# Access Compliance Report

## Public Rights-of-Way

### (Curb Ramps)

Intersection ID: 11980	Main Street: ALLEN_ST	Cross Street: E_17TH_ST	Location: W
ADA ID: 77848E6ECA86	Ramp Type: Directional1	Initial Pass/Fail: Pass	Overall Compliance: No
Codes/Mitigation Info/Possible Solution			Severity Score: 2.5
			Field Measurements/Component Compliance

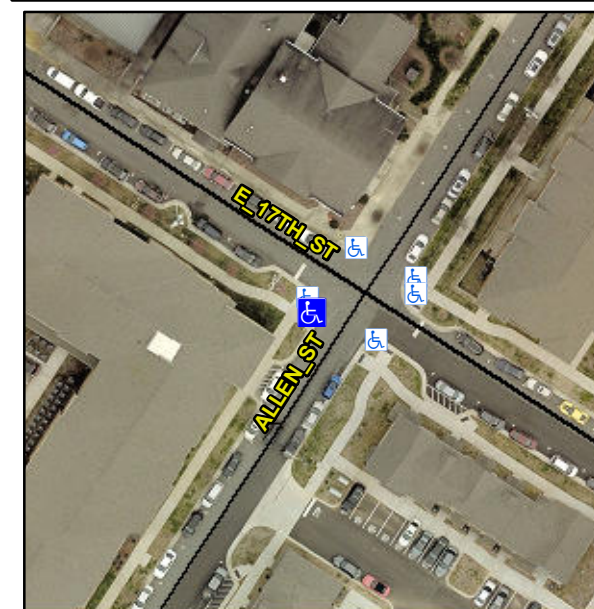
**Remove & Replace Detectable Warning System.**

**CONSTRUCTION**

**R305.1.4, R305.2**
